#### PLANNING AND ZONING COMMISSION AGENDA - Regular Meeting

### STAFF REPORT KETCHUM PLANNING AND ZONING COMMISSION MEETING OF JANUARY 14<sup>th</sup>, 2019

**PROJECT:** Redfish Residential Live-Work Unit #201 CUP

**REQUEST:** Conditional Use Permit (CUP) for the proposed conversion of Unit #201 of the Redfish

Figure 3. Proposed Unit #201 Floor Plan

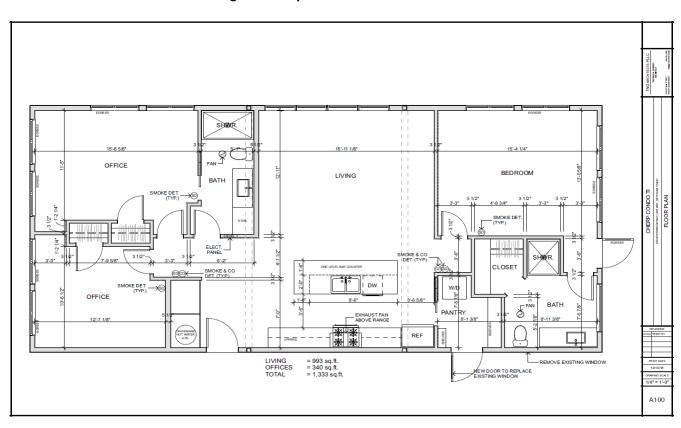
Unit #201 has a total floor area of 1,333 sq ft. As indicated on the floor plan (Sheet A100), the applicant has proposed converting 933 sq ft of Unit #201 to a residential dwelling unit with the remainder of the unit, 340 sq ft, designated as "office." The business and residential uses proposed share a main entrance into the unit and the office is separated by walls and accessed from the main entryway.

Business offices are prohibited in the LI-2 Zone. The proposed use diverges from the purpose of the LI-2 Zone as the real estate business office does not relate to manufacturing, construction, or other uses that define the character of the light industrial district. While diverse uses may occur within Ketchum's light industrial district, many LI uses cannot occur elsewhere in the City. Many light industrial uses, such as manufacturing, maintenance service facilities, repair shops, and motor vehicle service, are solely permitted in the light industrial districts. Business offices, such as the real estate establishment proposed by the applicant, are permitted in both subdistricts of the Community Core as well as the LI-3 Zone. Business offices are also permitted with the approval of a CUP in the Tourist Zone.

In order to accommodate a residential use, each of the second floor units in the Redfish building must contain a work component in order not to exceed the 1,000 sq ft maximum residential unit size restriction within light industrial districts. The remodel of Unit #201 would accommodate a home business, however the applicant's proposed work component is prohibited in the LI-2 Zone.

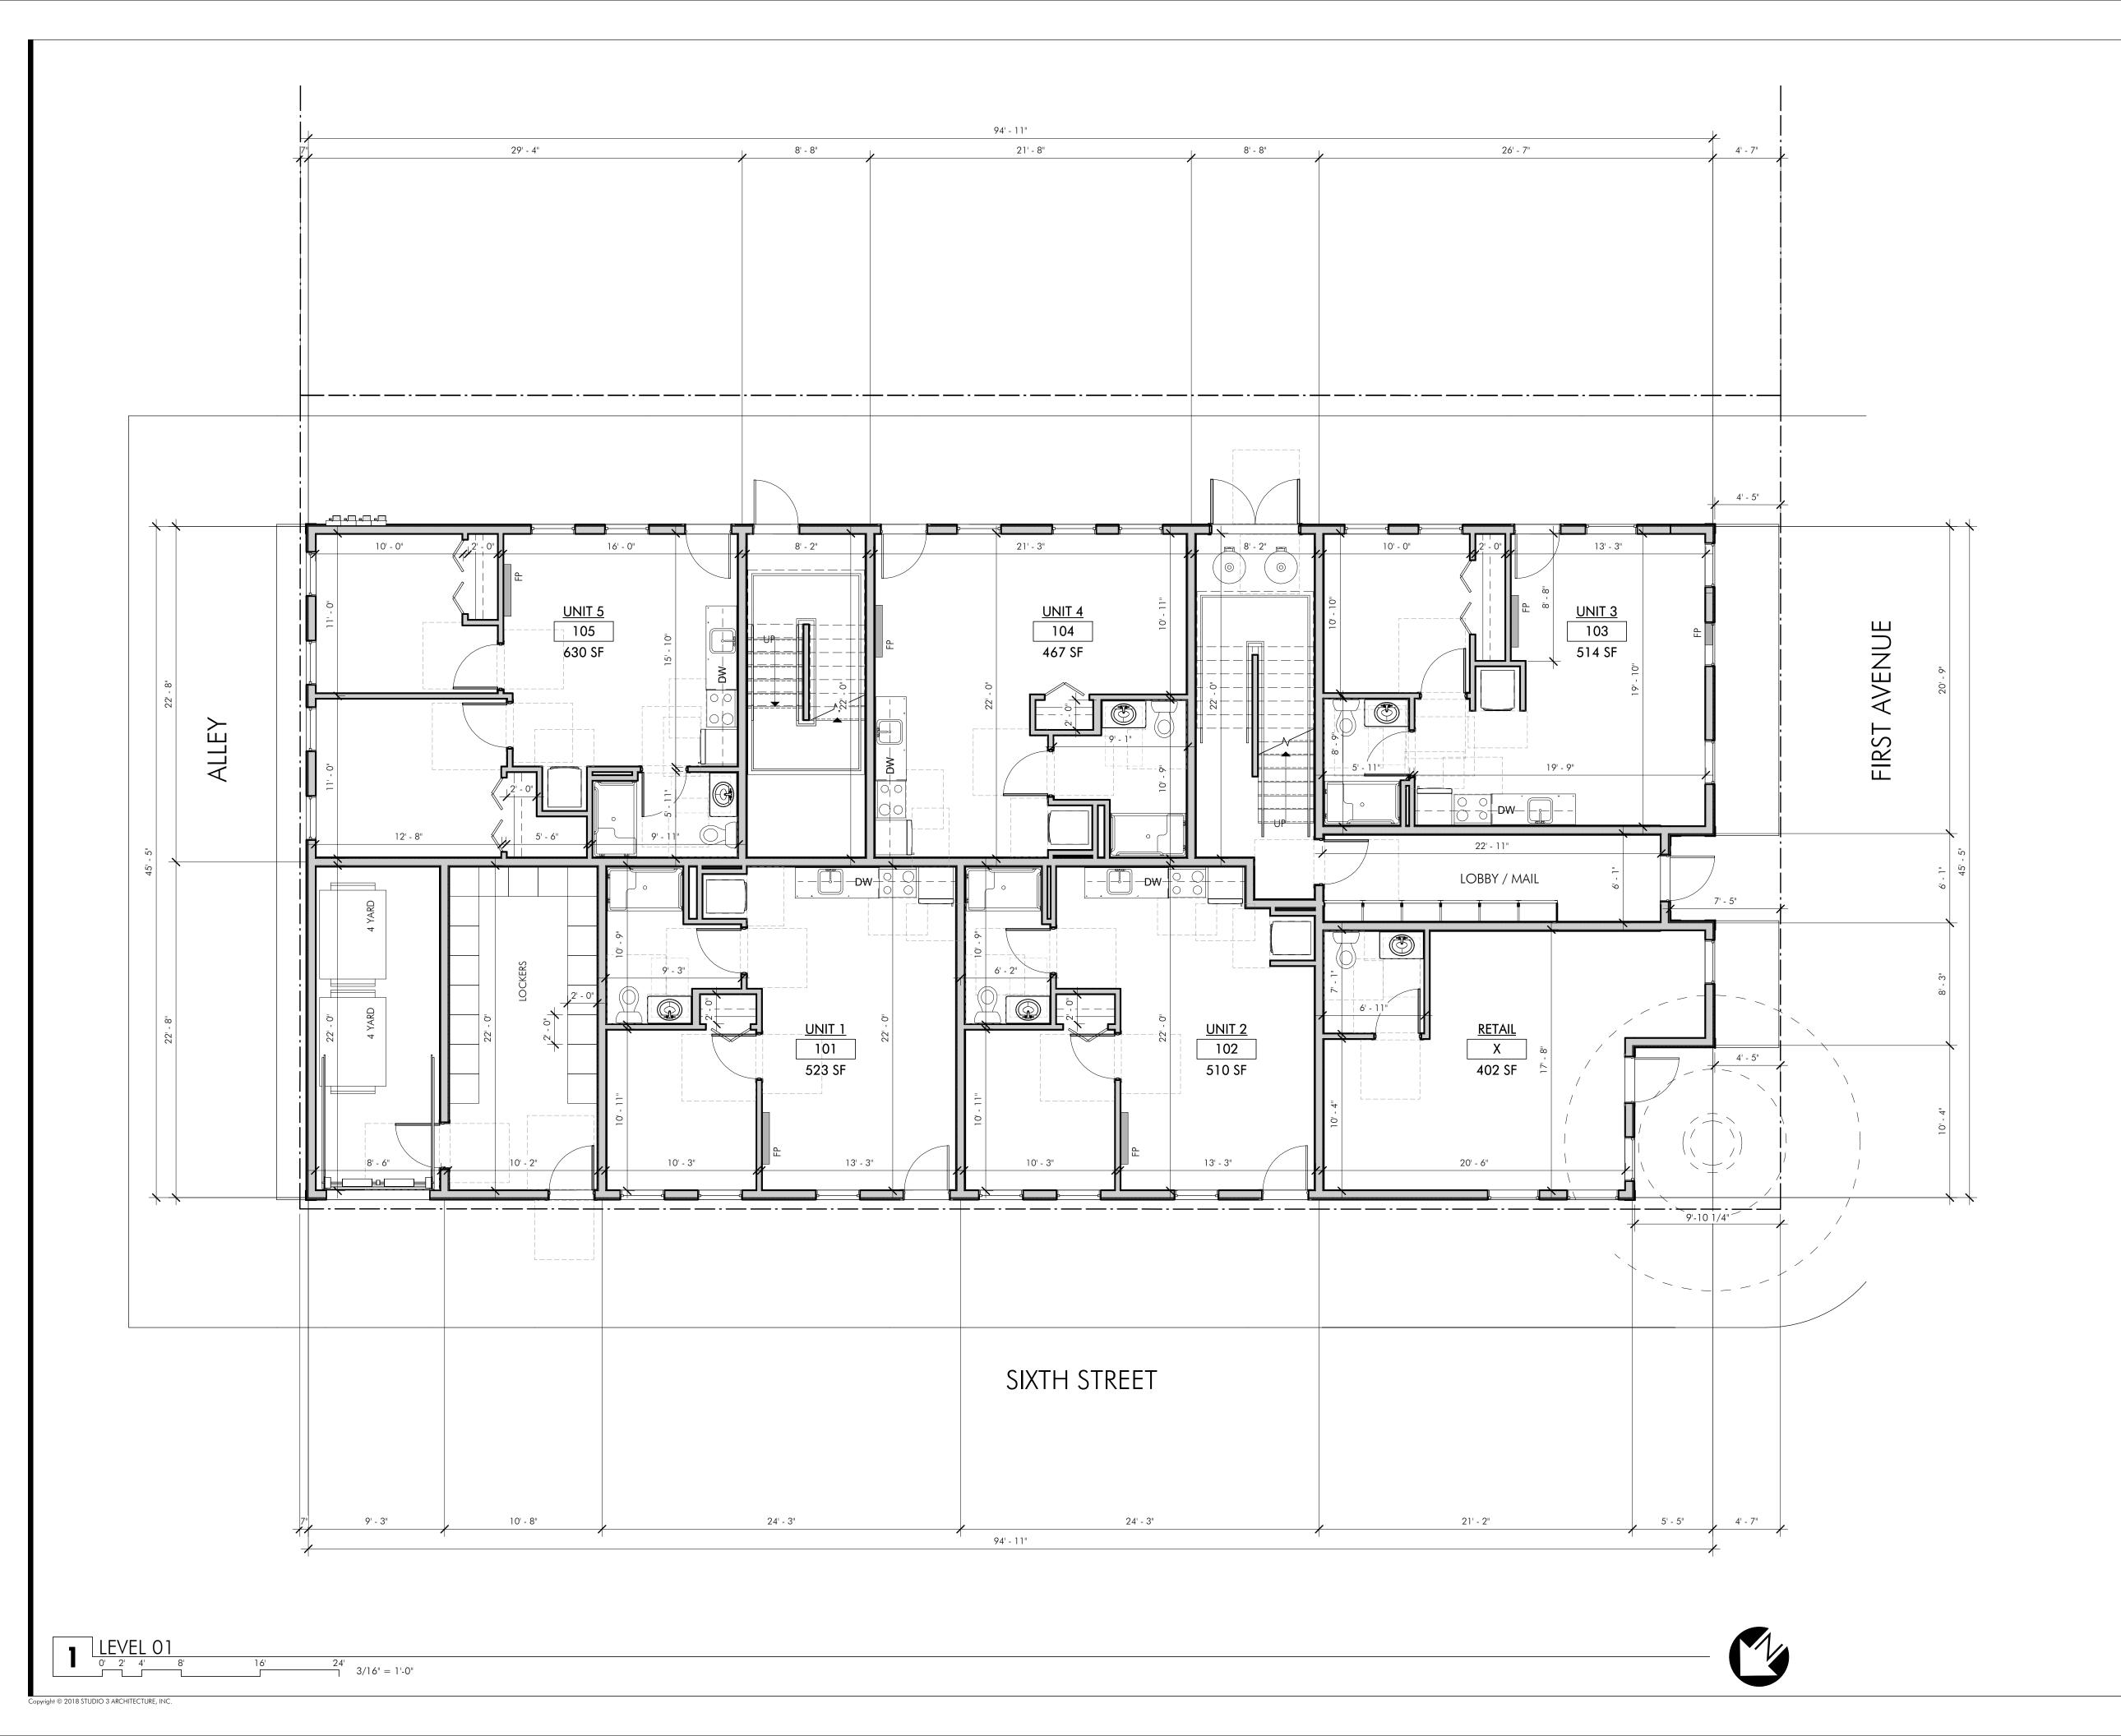
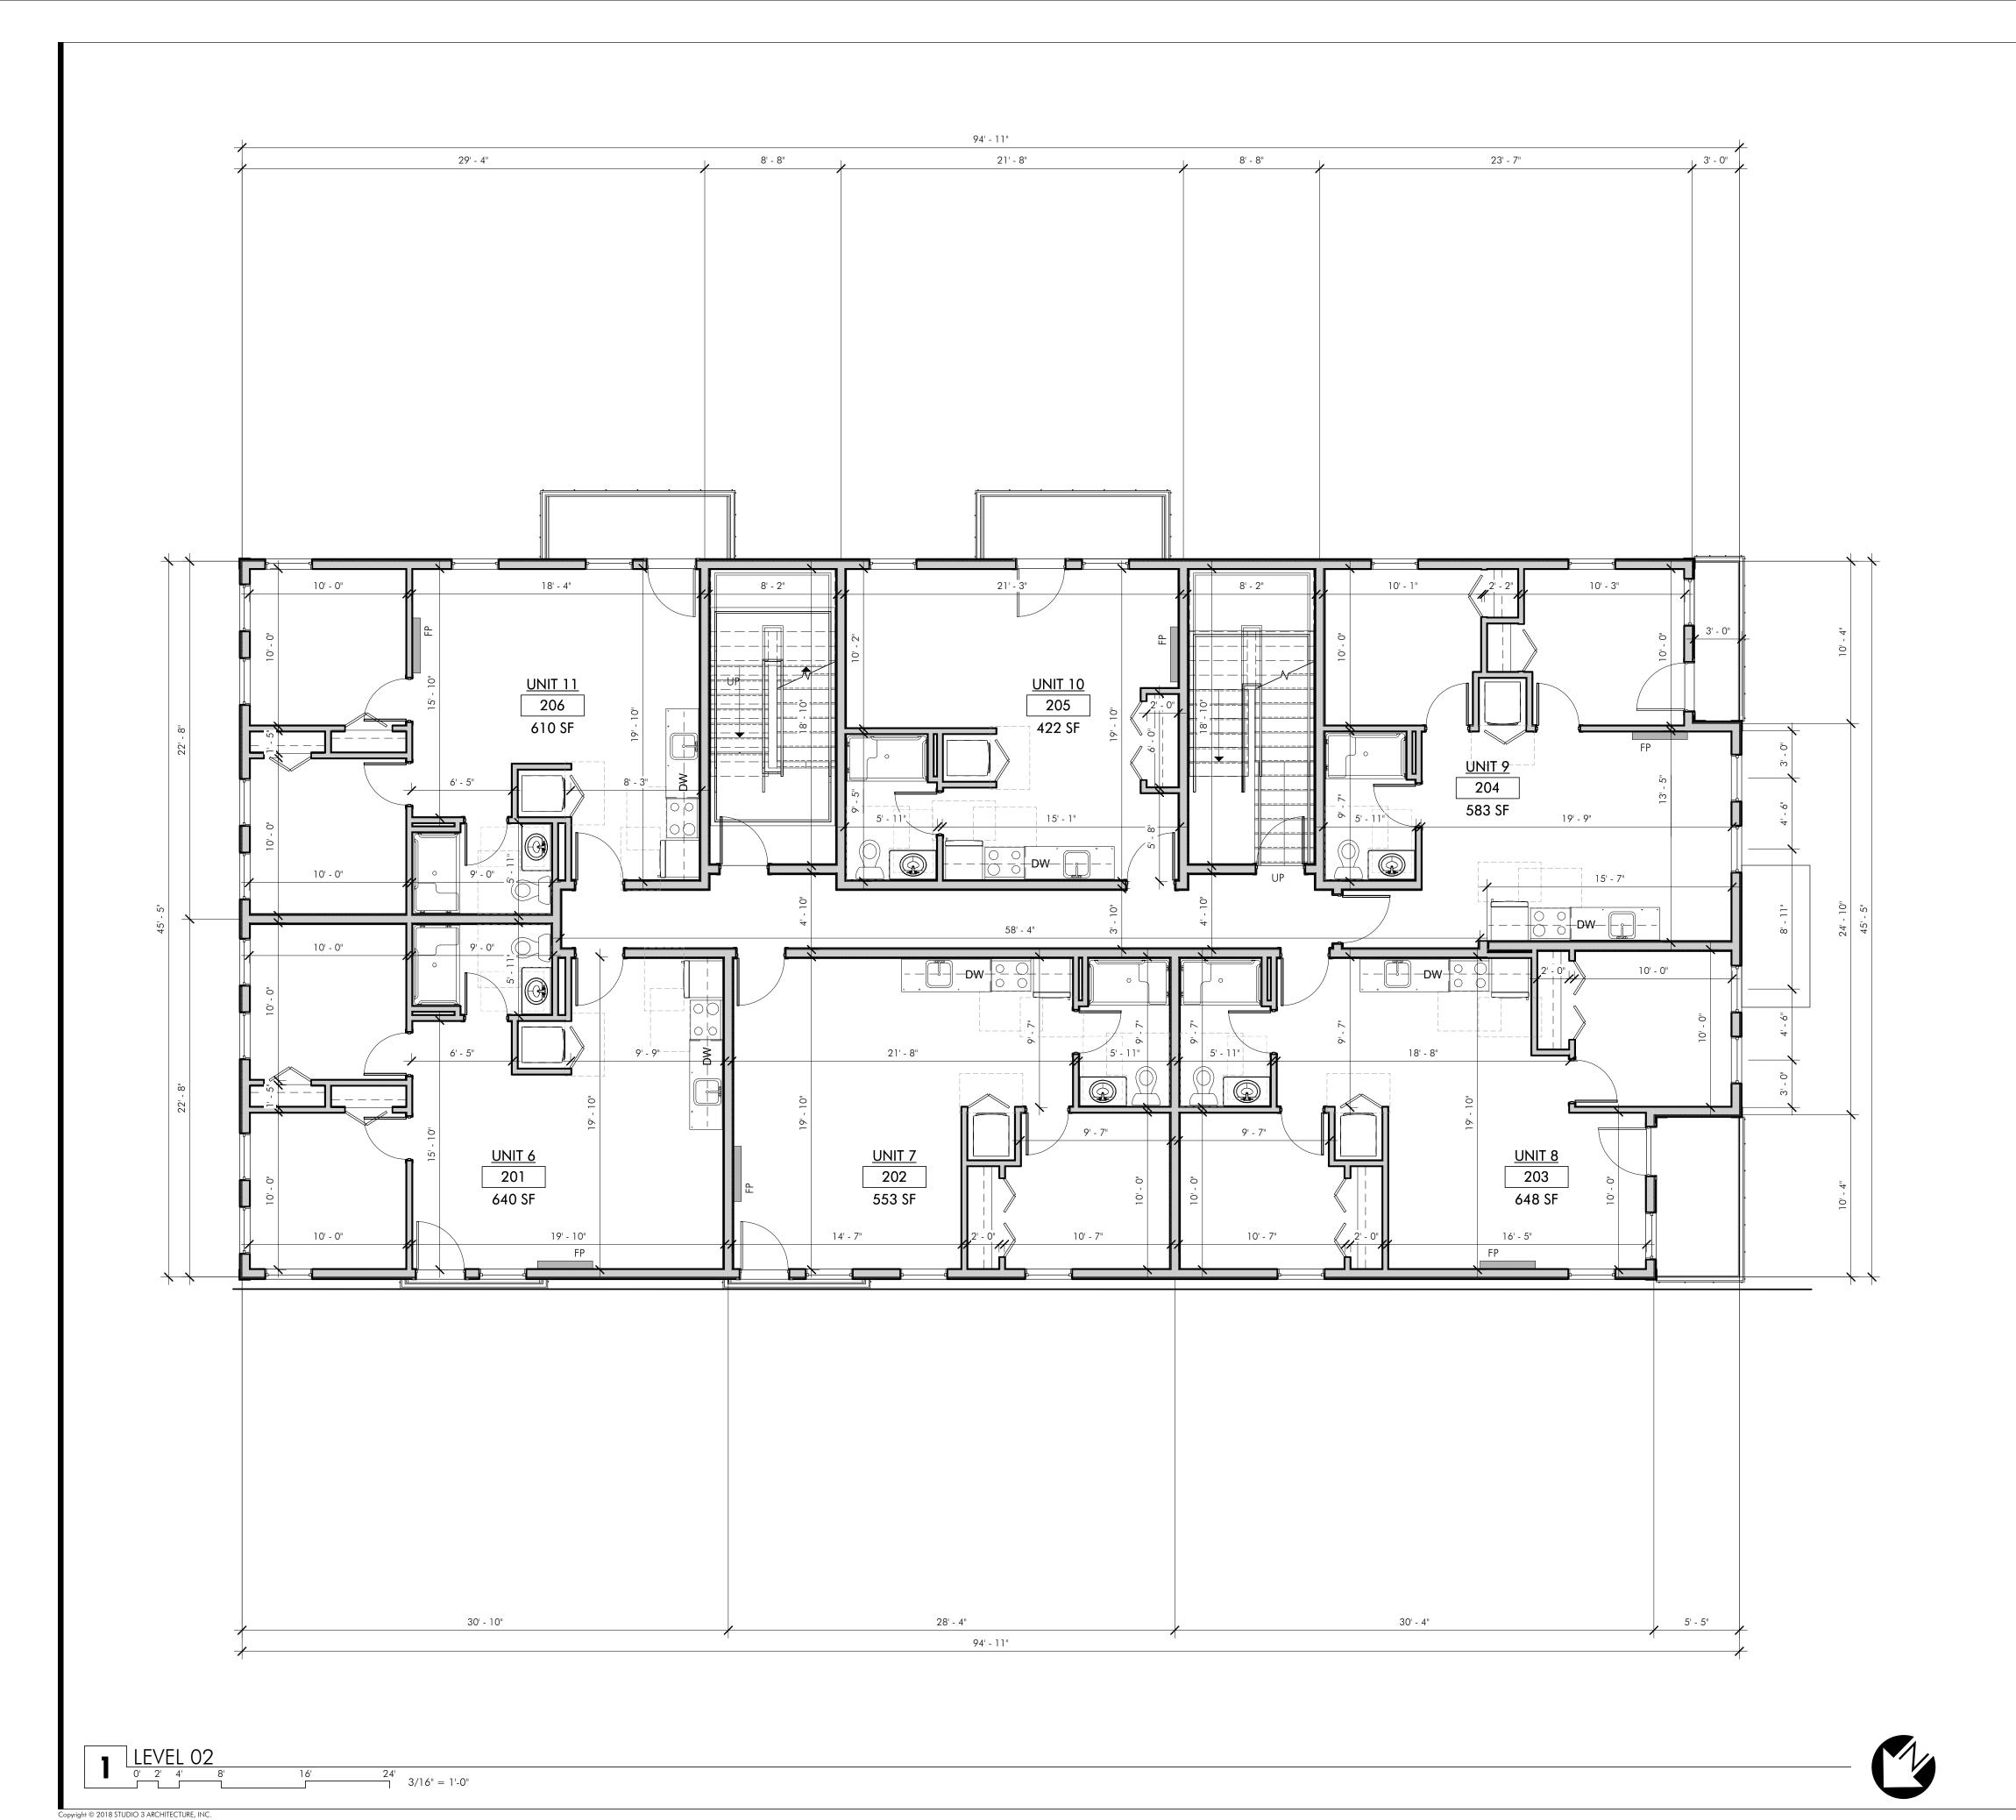
townscape, surrounding neighborhoods and adjoining structures.
			Staff Comments	The 3D color rendering sheet included in the plan set most accurately represents the
				proposed exterior colors of the project. The proposed color palette consists of medium
				to dark burgundy/chestnut brown/red hues for the siding and parapet accented by
				charcoal-colored belly band, corner, and cornice features.
				The materials consist of horizontal wood siding, 12" board and batten siding, steel-
				framed balconies and balconettes with wood slats and decking, and 18" aluminum
				lettering denoting the name of the development, "Ketch 2."
				Total Line and the development recent Zi
				These medium-to-dark earth tones are complementary to the adjacent Ketch 1
				building and other buildings in the vicinity that have muted, earth tone hues. Other
				buildings in the vicinity have facades comprised primarily of natural and composite

used on the balconies and balconettes throughout. However, the parapet wall, which
				uses horizontal battens siding and is met by a 24" deep band below, adds
				complementary height to the primary vertical mass of the building, which reduces the
				appearance of flatness.
				appearance of framess.
				Additionally, the substantial amount of glazing for the windows and doors, along with
				the balconies and balconettes, punctuate the mass of the building – reducing the
				appearance of bulk - and provide visual interest.
$\boxtimes$			17.96.060(F)(3)	There shall be continuity of materials, colors and signing within the project.
			Staff Comments	The same materials and color schemes are used on all four facades of the building.
	$\boxtimes$		17.96.060(F)(4)	Accessory structures, fences, walls and landscape features within the project shall
				match or complement the principal building.
			Staff Comments	Accessory structures, fences, and walls have not been proposed and are not required.

Staff Comments	For properties located on a corner the shortest lot line is considered the front, or
				primary frontage. In this case the primary street frontage is 1 <sup>st</sup> Avenue and the
				building orients toward it; the main entrance as well as the building signage are
				located on the 1 <sup>st</sup> Avenue side of the building.
$\boxtimes$			17.96.060(F)(7)	Garbage storage areas and satellite receivers shall be screened from public view and
				located off alleys.
			Staff Comments	The first-floor plan and the rendering sheet indicate that the garbage storage area will
				be enclosed within the building. No satellite receivers are proposed.

Self Comments   There is one accessory retail space, 402 square feet in size, proposed at the corner of 6"Street and 25t Avenue. The elevations and enderings indicate a glass strong from windows of the same dimension as the entry door. For nonresidential portions of buildings, front facades shall be designed to not obscure views into windows.    Self Comments   The nonresidential portion of the building has been designed with ample windows and a glass door in order to provide views into the commercial space.   Roofing forms and materials shall be compatible with the overall style and character of the structure. Reflective materials are prohibited.    Staff Comments   The form of the roof) is of fact roof. The roofine is defined by a 6" high parapet wall that is visually separated from the third story by a prominent belt band that has a 24" overhang. The color of the roof is the same color as the ground floor wood siding and the bond is the same color of the roof is the same color as the ground floor wood siding on the bond is the same color of the building façade. No reflective materials are proposed.   All pitcher forofs shall be designed to sufficiently hold all snow with snow clips, gutters, and downspouts.		1	1
